Pre-Plaster Inspection Report

Dwelling type:	House and Garage.
Dwelling configuration:	Single Storey.
Nature of works:	New Building.
Stage of inspection:	Frame
Construction Type:	Brick Veneer.
Garage:	Attached.
Foundations:	Slab.
Builder:

TABLE 9.4
NOMINAL FIXINGS FOR TIMBER MEMBERS

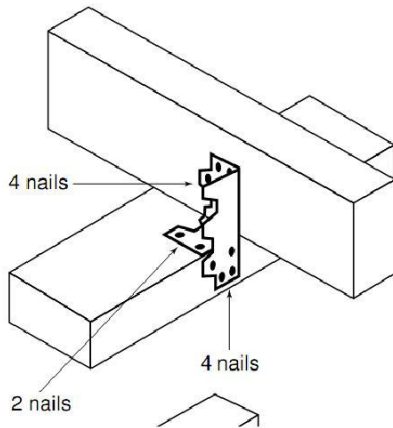
2. The roof beams over the portico and alfresco area has not been tied or bolted to the post supporting them.

I refer the builder to AS 1684.2, clause 9.5, and Table 9.4 under the heading of nominal fixings. It states; *Verandah beams and roof beams shall be joined to post with 1/M12 or 2/M10 bolts*. Nails and hooping iron are not noted on the Intrax engineering or the Australian Standard. To substitute hooping iron at the front or rear will require an engineering compliance assessment.

Please note that the alfresco has no bolt or hooping iron holding down the whole of the alfresco roof. Framing nails installed are clearly inadequate.

FIGURE 6.6 NOGGING

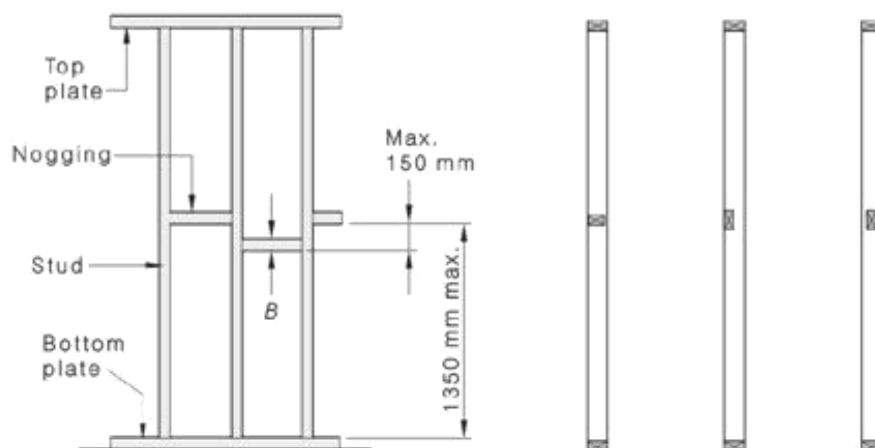
7. There are several noggings that need to be installed or in parts reinstalled.

I noted that the ensuite noggings have been installed at greater than 1350 mm separation.

I refer the builder to AS 1684.2, clause 6.2.1.5 which calls for all noggings to be installed at no greater than 1350 mm from top or bottom plate and no greater than 1350 centres.

The missing noggings will need to be installed as marked up on site prior to lockup completion.

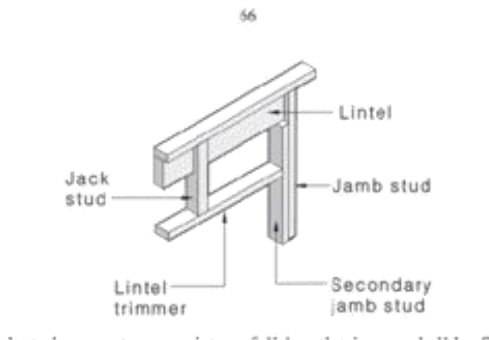
12. The jack studs under the lintels must be installed hard under the lintel or an additional section of timber installed so that the brick layer has a connection point for the brick ties. We refer the builder to AS 1684.2, clause 6.2.3 which calls for all jack studs to be the same orientation as the standard studs, however does not make same compulsory.

However, given the requirement for the brick ties to be doubled up around windows and doorways, the only way to comply with this mandated requirement is to install additional material to the jack studs or rework the manner in which they are installed.

Failure to install or rework this item will result in a later defect on the brick tie requirements above all openings.

FIGURE 4.2.2(A) ASSESSING FRAMING TOLERANCE

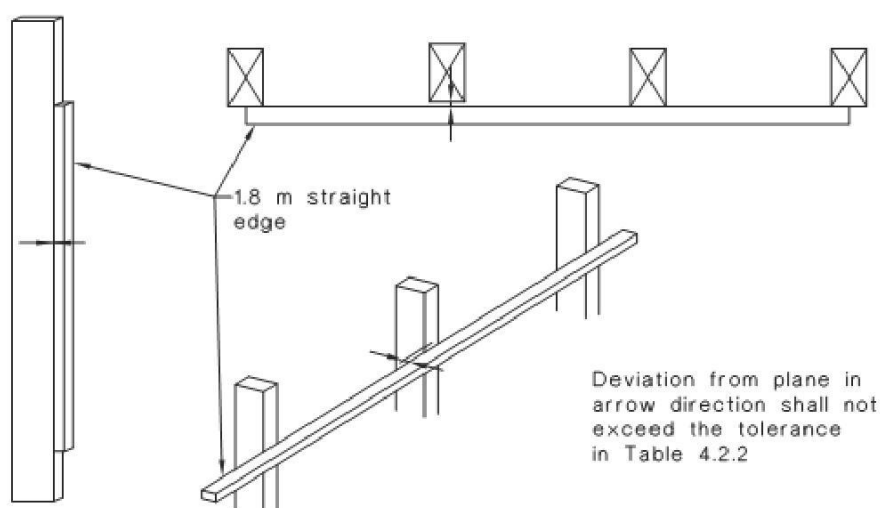
17. I was able to detect a small number of walls on the dwelling that exceeded the allowance of 4 mm tolerance over 2 m. These walls have been marked up with paint and OOP (out of plumb) painted on the floor.

As stated, the acceptable allowance is 4 mm over 2 m. The walls will need to be reworked to ensure that the builder complies with this requirement.
